Addendum No. 1
May 11, 2023

JSD Jefferson E.S.

Musgrove Engineering Mechanical Addendum #1 dated 5/11/23, (7) pages, with (36) revised and attached drawing sheets.

Musgrove Engineering Electrical Addendum #1 dated 5/11/23, (3) pages, with (6) revised and attached drawing sheets.

P-2.4

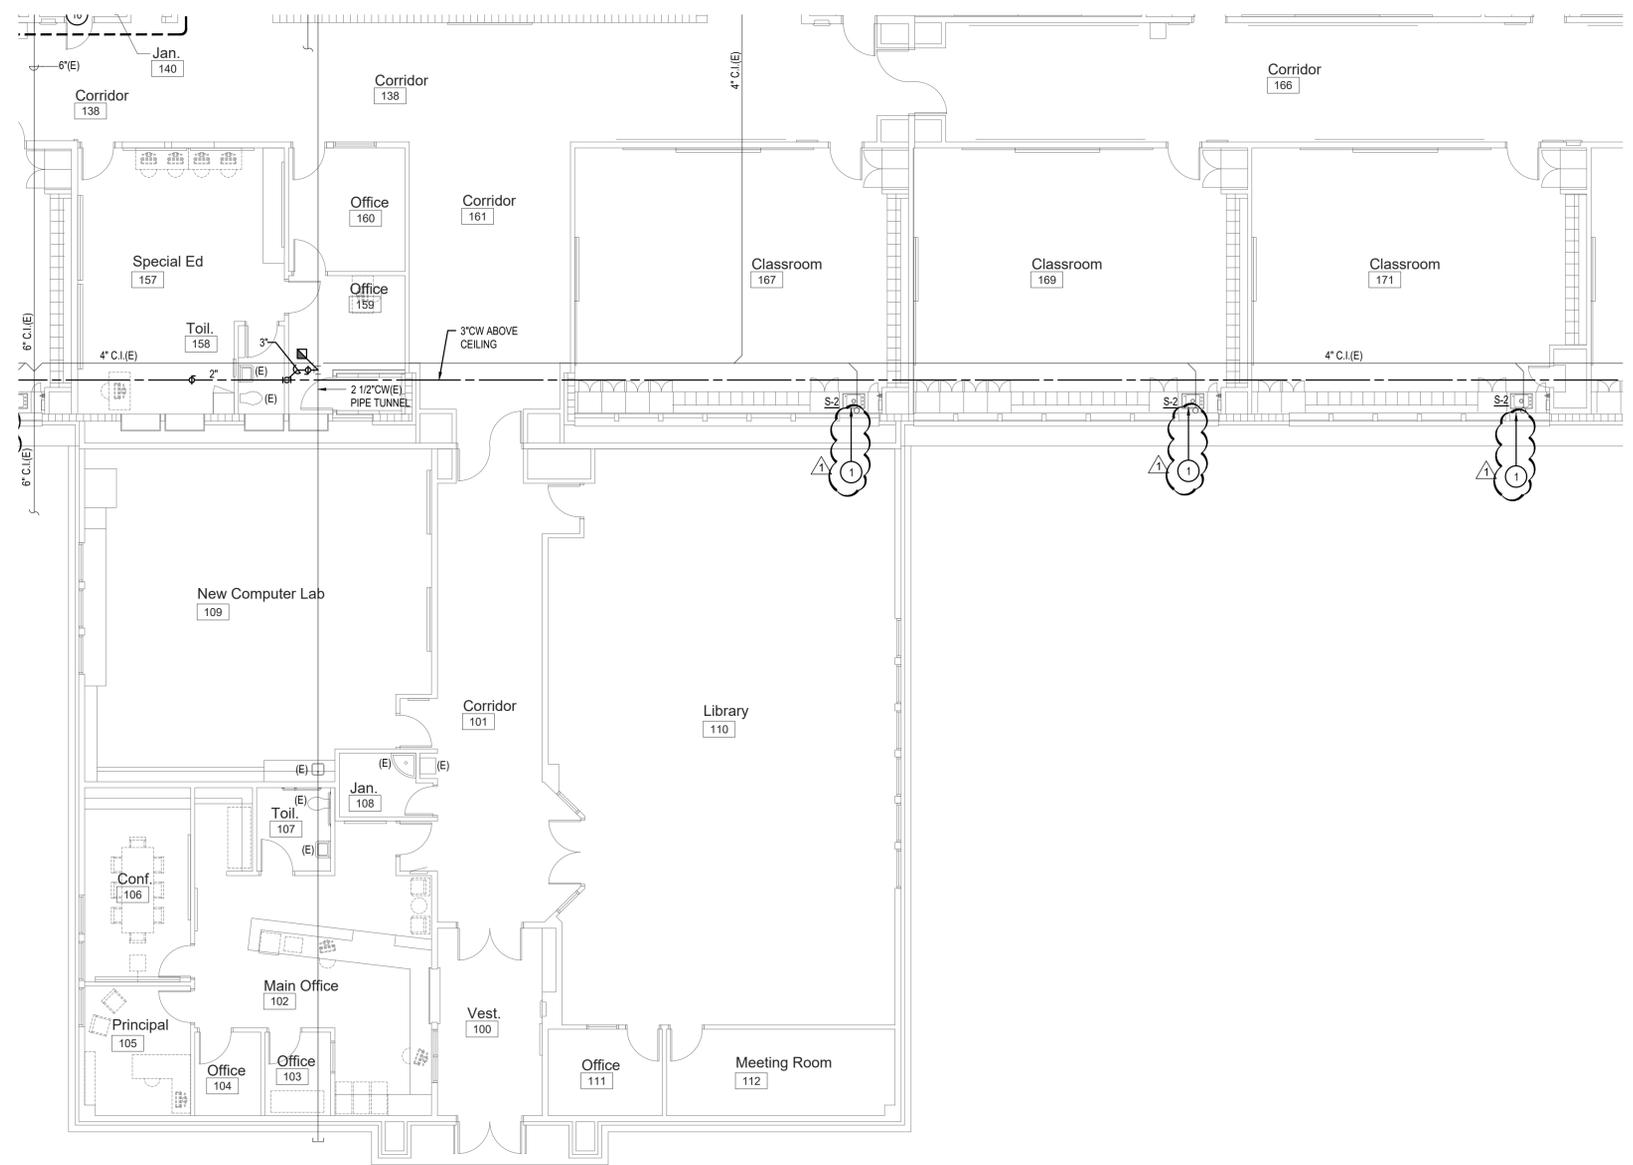
1. Added typical keynote 6 for S-2 sinks.
2. Changed callout for WC-3 to WC-2.
3. Added new to existing symbol in prep room 179.

7 MAKE-UP AIR EVAP COOLER PIPING DETAIL
NOT TO SCALE

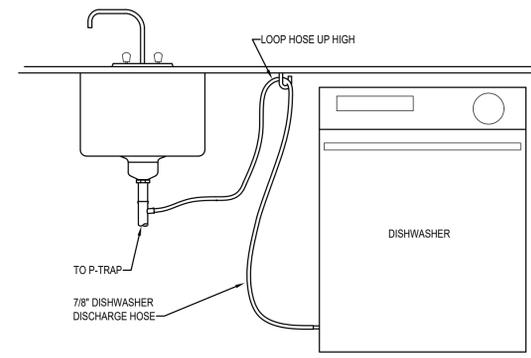
1. Added Detail 7 Make up air Evap Cooler Piping Detail
2. Added Detail 8 Dishwasher Connection Detail.

6 ROOF MOUNTED PIPING DETAIL
NOT TO SCALE

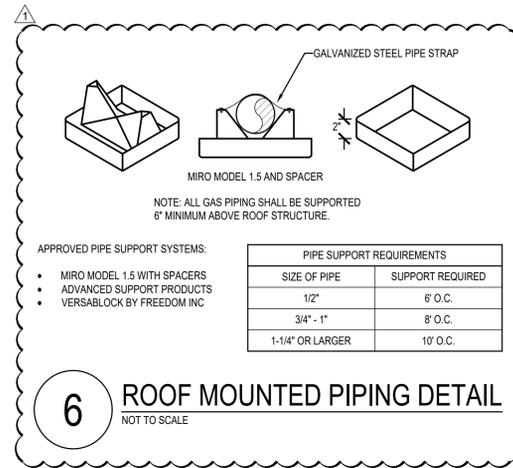
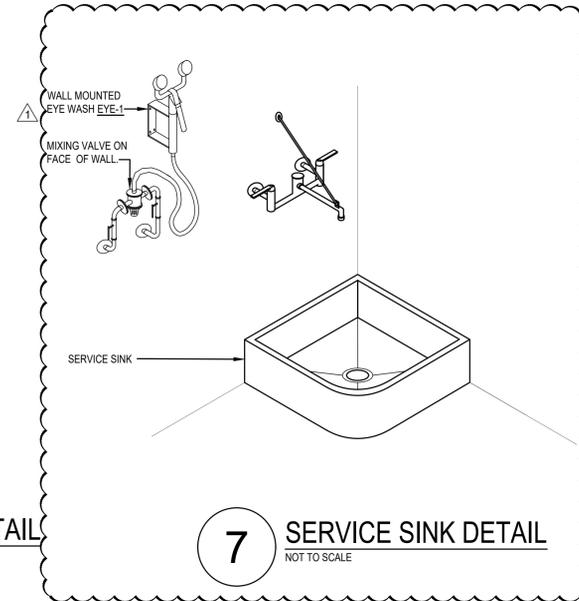
1. Added Detail 6 Roof Mounted Piping Detail.
2. Added Detail 7 Service Sink Detail.
3. Added Detail 8 Trap Primer Connection Detail.

E-5.3

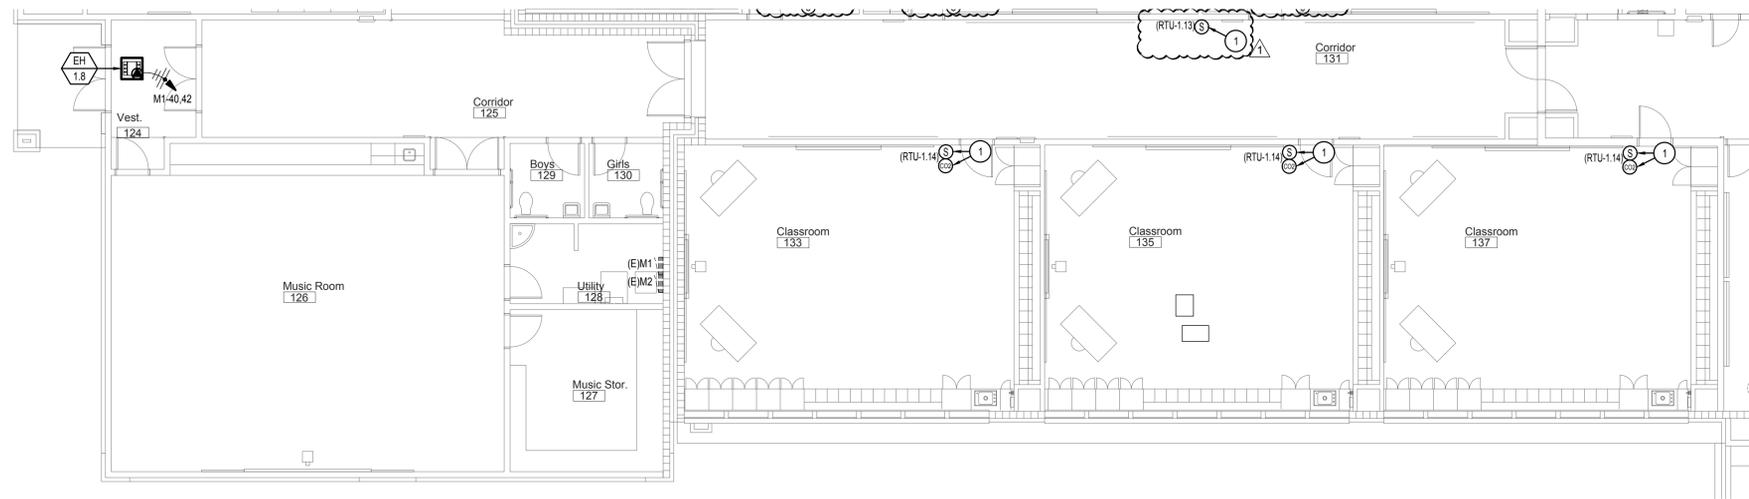
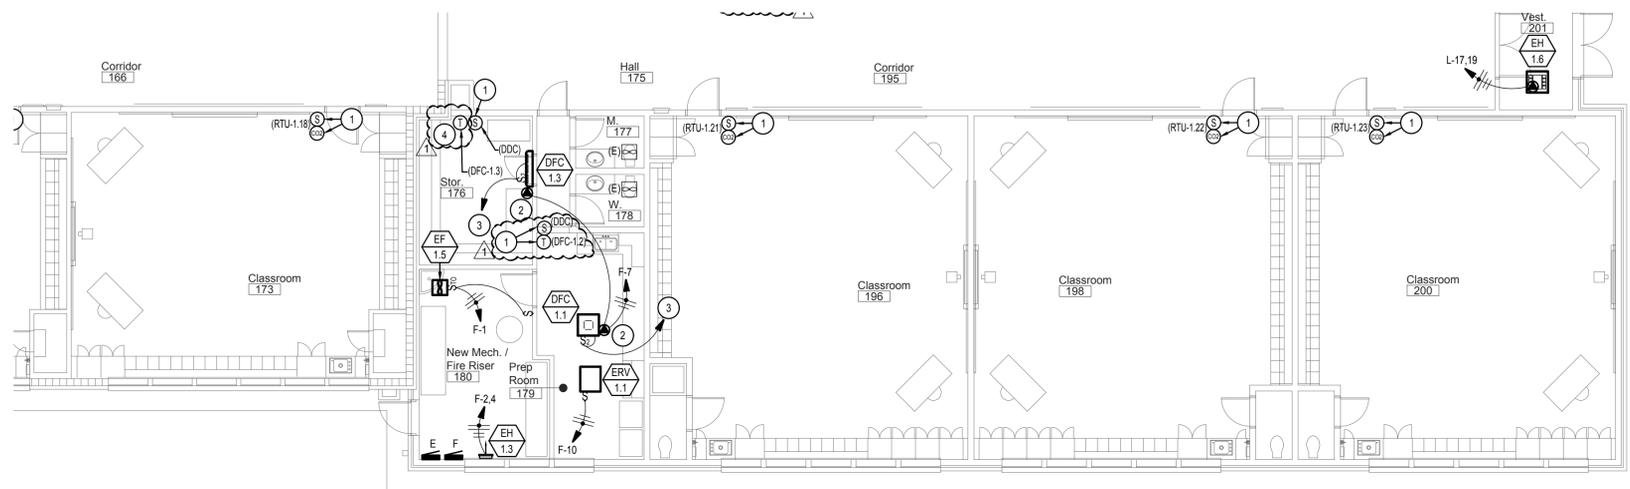
3. Sheet E5.1 – MECHANICAL POWER PLAN – AREA 'A'
 - a. Mechanical T-stat and sensors added (RTU-1.1), New Office 132, Classroom 134, Classroom 136.
4. Sheet E5.2 – MECHANICAL POWER PLAN – AREA 'B'
 - a. EH-1.7 updated to EH-1.10
 - b. Mechanical sensor added for hoods, New Kitchen 152.
 - c. Mechanical sensors added, New Cafeteria 163.
 - d. Remove wall t-stat for heaters EH-1.4 Vest. 164. T-stat integral
 - e. Updated Keyed Notes to DFC-1.1, I.T./Server 150
5. Sheet E5.3 – MECHANICAL POWER PLAN – AREA 'C'
 - a. Remove wall t-stat for heater EH-1.1 and EH1.5, Ramp 190. T-stat integral.
 - b. Mechanical sensor added, New Gymnasium 184

- c. Mechanical sensor removed (RTU-1.20), Corridor 195
6. Sheet E5.4 – MECHANICAL POWER PLAN – AREA 'D' AND 'E'.
 - a. Mechanical sensor removed (RTU 1.13), Corridor 131.

DRAWING NO.
E-7.1

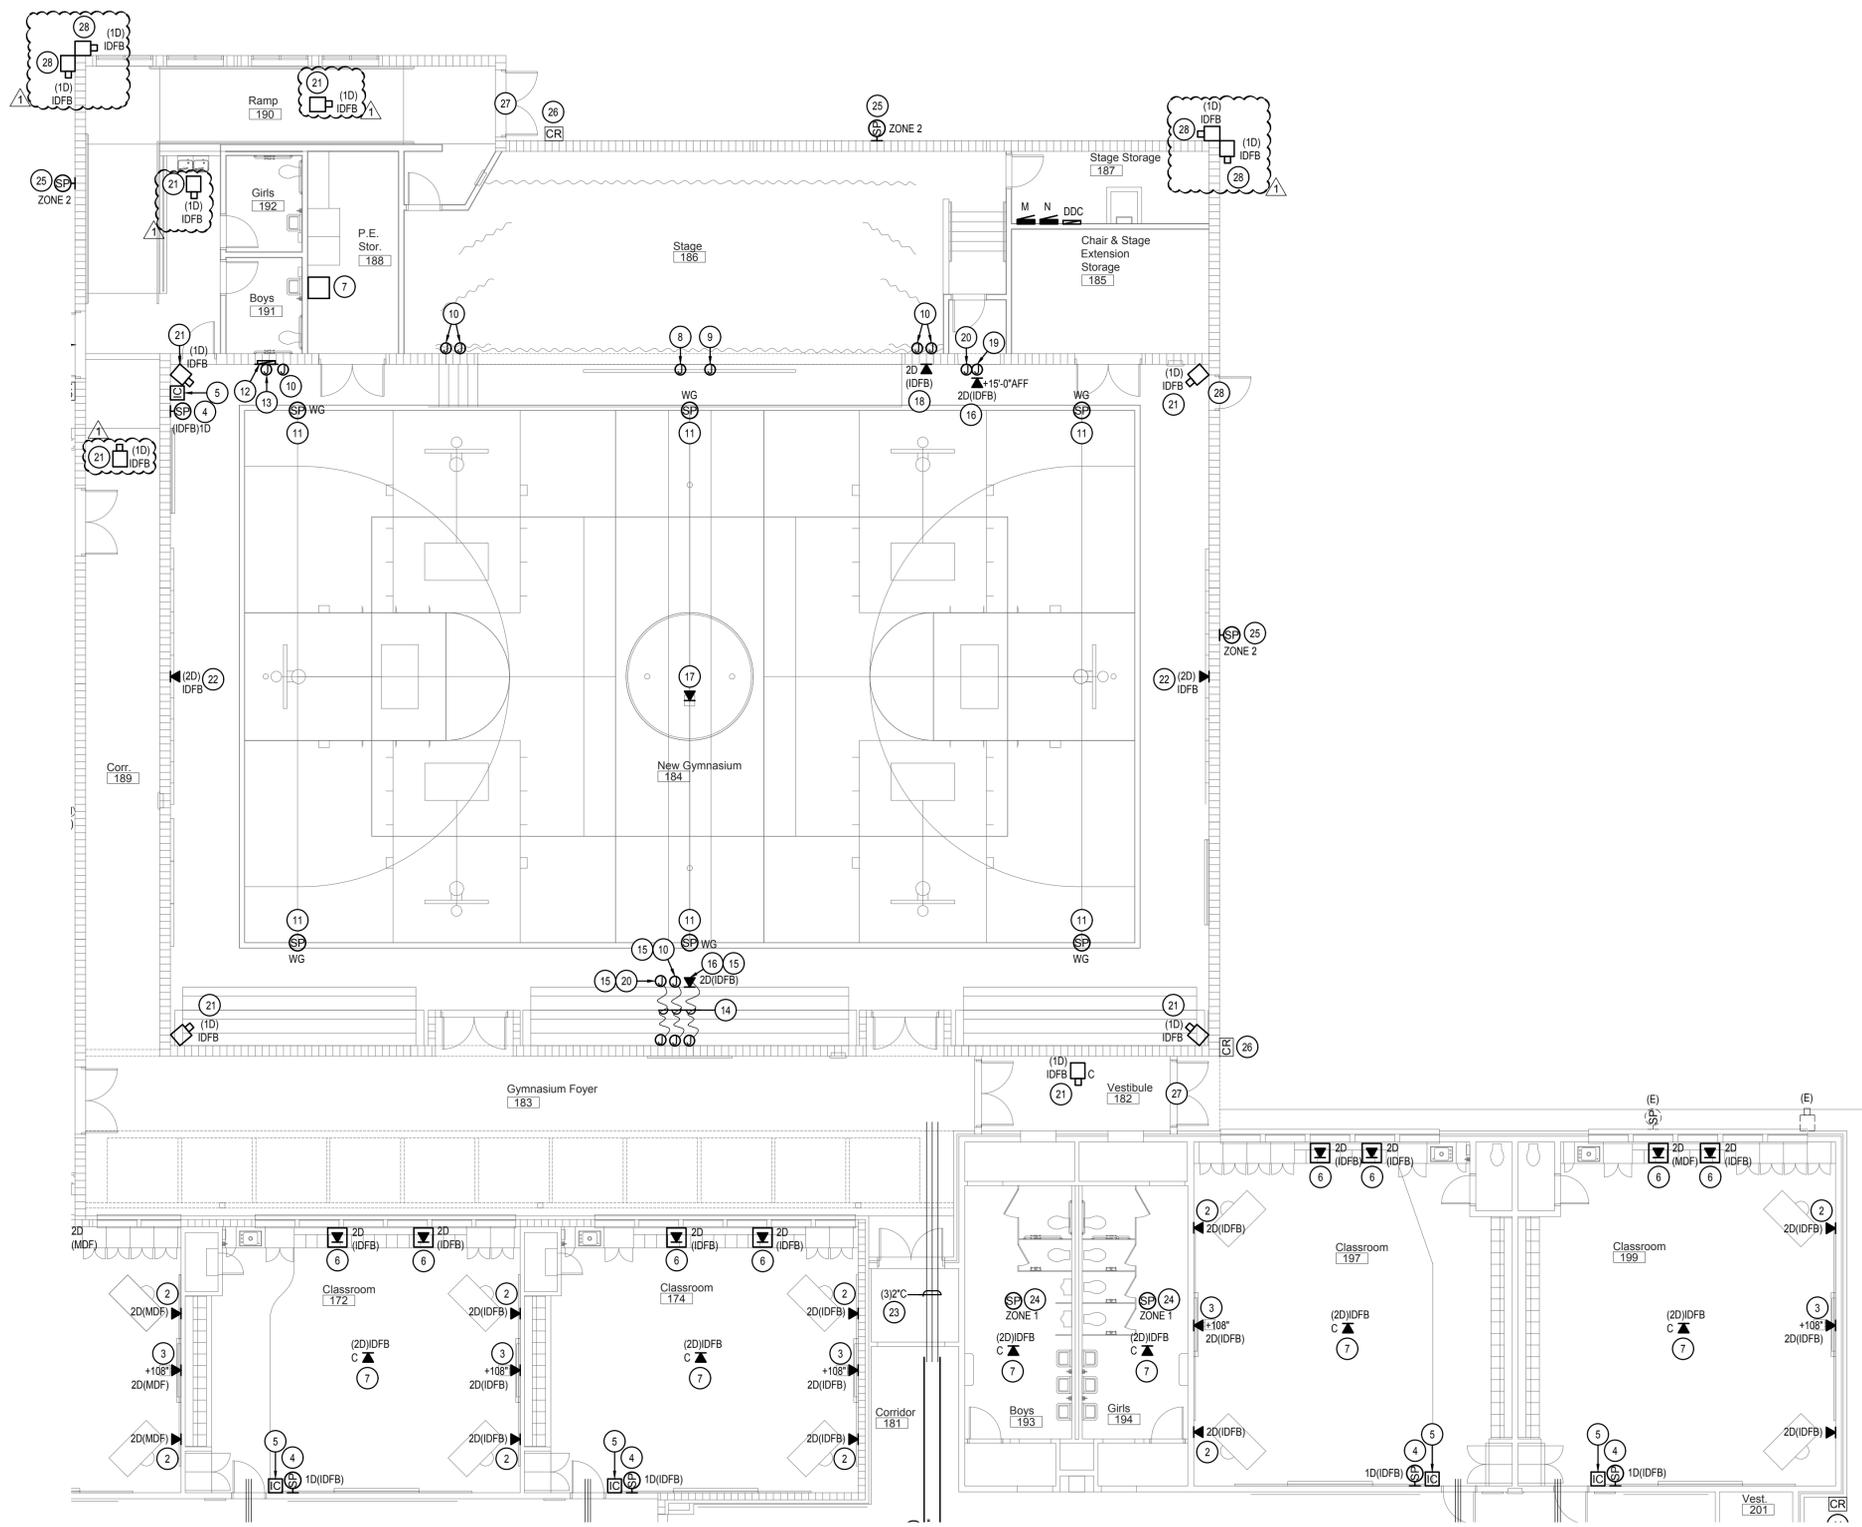
- a. Revised Keyed Note #8 for interior security cameras. See new interior Keyed Note below.
 - b. Added exterior camera, Added Keyed Note #12. See new exterior Keyed Note below.

INTERIOR SECURITY CAMERA FURNISHED AND INSTALLED BY THE OWNER. CONTRACTOR TO PROVIDE SURFACE MOUNTED DATA BOX (BISCUIT), WITH QUANTITY OF DATA PORTS AS INDICATED, ABOVE THE ACCESSIBLE CEILING OR AT THE BUILDING STRUCTURE FOR SECURITY CAMERA CONNECTION. COORDINATE THE DATA OUTLET AND CAMERA LOCATION WITH THE SCHOOL DISTRICT PRIOR TO INSTALLATION. PROVIDE DATA CABLES; QUANTITY AS INDICATED, TO A DEDICATED, POE, PATCH PANEL IN DATA RACK INDICATED.

EXTERIOR, WALL MOUNTED, SECURITY CAMERA FURNISHED AND INSTALLED BY THE OWNER. CONTRACTOR TO PROVIDE A JUNCTION BOX AT 12'-0" AFG AND 3/4" CONDUIT FROM THE JUNCTION BOX TO THE NEAREST ACCESSIBLE CEILING SPACE. PROVIDE SURFACE MOUNTED DATA BOX (BISCUIT) WITH QUANTITY OF DATA PORTS AS INDICATED, IN THE JUNCTION BOX. COORDINATE THE DATA OUTLET AND CAMERA LOCATION WITH THE SCHOOL DISTRICT PRIOR TO INSTALLATION. PROVIDE DATA CABLES; QUANTITY AS INDICATED, TO A DEDICATED, POE, PATCH PANEL IN THE DATA RACK INDICATED.
